## Aquatic Effects Monitoring Plan (AEMP)

#### Consideration of Comments and Recommendations Stemming From the AEMP 2015 and 2016 Annual Report Submissions

### Environment and Climate Change Canada (ECCC) AEMP Revision 2 Comments and Discussion

### ECCC Comment 1: Figure Quality

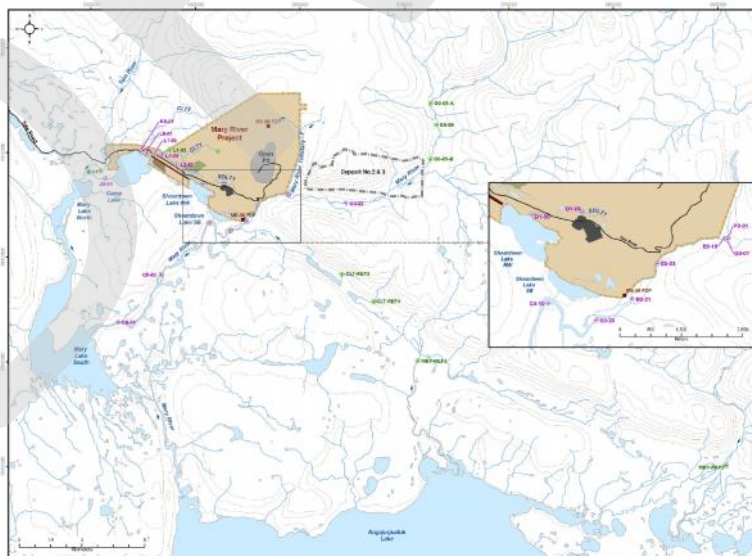
The low resolution of some of the figures provided in the document makes it difficult to read text and discern map details.

The quality of the figures and maps in the Plan should be enhanced to make the details clear to the reader.

### ECCC Comment 4: Changes to Number of Lake Stations

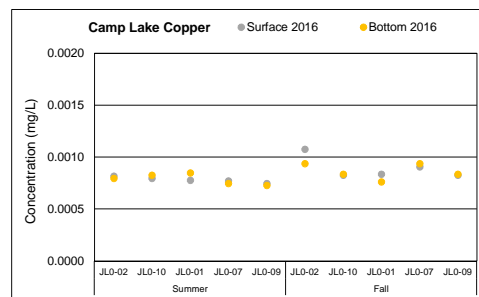
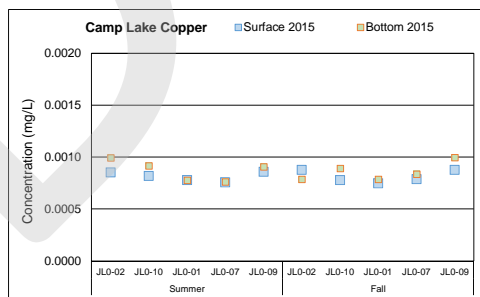
Minnow has recommended reducing the number of water quality monitoring stations to three in each of Camp, Sheardown NW, and Sheardown SE Lakes, and to four in Mary Lake. This reduction is based on assessment of baseline data which suggested that the lakes are well mixed making additional sampling stations redundant. ECCC notes that many of these sampling locations were added to the program based on a power analysis completed in 2014 by Knight Piesold Consulting.

- The methods used for the 2014 power analysis were appropriate, though the information from the power analysis is not appropriate for determining the number of stations required.
- Parameters considered for the 2014 power analysis have since been shown not to not all be “most affected parameters during mine operation”. For example, ‘elevated’ aluminum concentrations appear to be largely natural, and sodium/uranium not considered.
- As correctly identified in the 2014 power analysis, once data collected from mine operational period, linear regression models will be appropriate for testing differences between baseline and mine operational periods, and considering reference area data.

## ECCC Comment 5: Changes to Number of Stream Stations

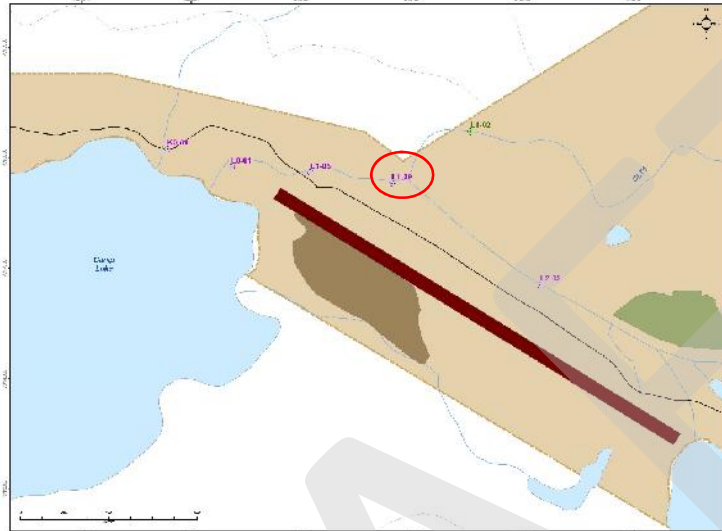
Minnow has recommended that the AEMP discontinue water quality monitoring at stations L1-09 (Camp Lake Tributary), D1-05 (Sheardown Lake Tributary 1) and G0-09A, G0-09B, and C0-01 on the Mary River. The reason for discontinuation of sampling at these locations is redundancy (L1-09 and C0-01), with the rationale that a single reference sampling location in the Mary River is adequate (G0-09A and G0-09B), and that an upstream sampling location is not necessary (D1-05). ECCC notes that many of these sampling locations were added to the program based on a power analysis completed in 2014 by Knight Piesold Consulting.

- With the suggested removal of Stations L1-09, D1-05 and CO-01, sampling locations are being maintained that will produce data to determine if there are potential impacts to these waterbodies (i.e., they don't add additional information).

## INAC 2015 Comment 2: Water Quality Top-Bottom Sampling

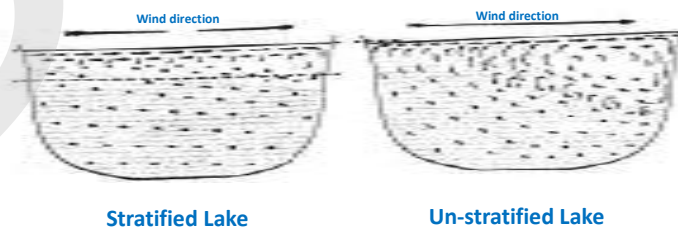
INAC recommends that continuing lake water quality sampling at two depths (1 m below surface and 1 m above bottom) rather than at a single depth (mid-water column).

- The provision that a top-bottom sampling approach be used in the event of thermal stratification should have been included in the main text of the AEMP Revision 2.

## INAC 2015 Comment 2: Water Quality Top-Bottom Sampling

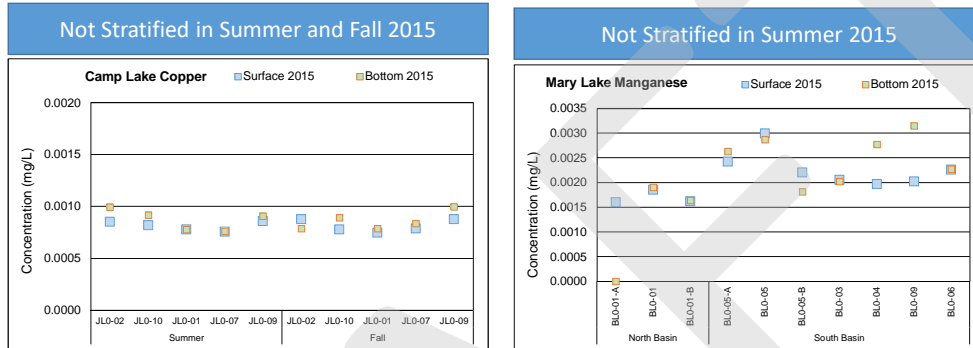
The revised plan proposes to "collect a single water quality sample at mid-depth instead of collecting two samples, surface and bottom, at each lake water quality monitoring station" (Minnow recommendation #9). The justification given is that "water chemistry data collected during the 2015 CREMP, as well as during baseline studies, has generally shown only minor (i.e., <2-fold higher) differences in water chemistry and chlorophyll a concentrations between the surface and bottom at each station."

- Absence in thermal stratification reflected as minor differences in chemistry between top and bottom.
